Subject: CHECK ENGINE LIGHT ON WITH DTC P0191:00 OR P0088:00	Bulletin No: 01-004/15
	Last Issued: 04/08/2015

2012-13 Mazda3 (with SKYACTIV 2.0L)

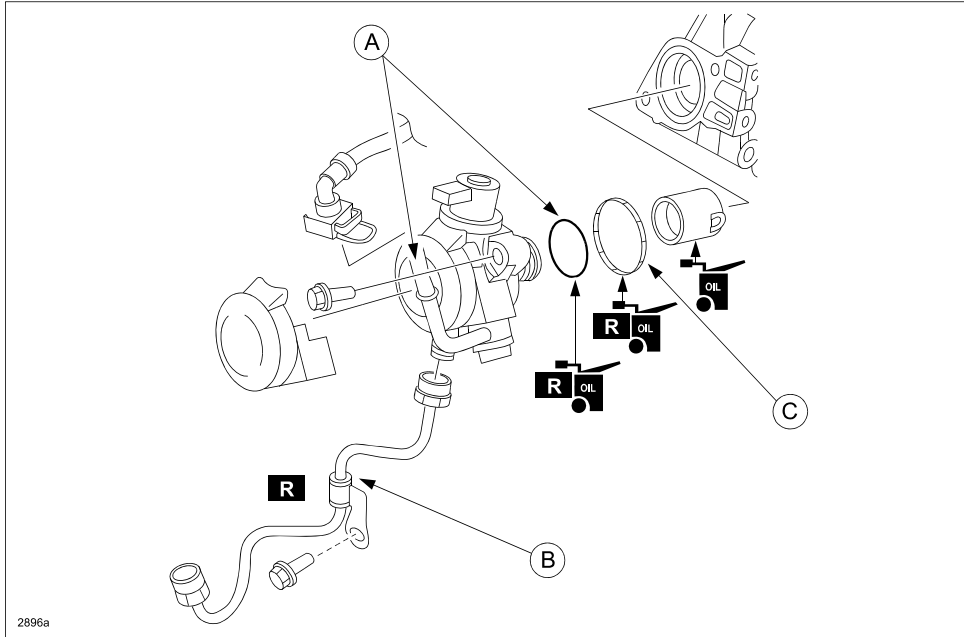
This is caused by the high pressure fuel pump not generating the target fuel pressure (due to a manufacturing error of the inner parts). To correct the problem, production control has been improved.

1. Verify customer concern.
2. Replace the high pressure fuel pump with a modified one according to the Workshop Manual.
3. Replace the high pressure fuel pump (A: fuel pump; B: fuel pipe; C: rubber seal) with a modified one according to the instructions on MS3 online or the Workshop Manual (section 01-14 HIGH PRESSURE FUEL PUMP REMOVAL/INSTALLATION).
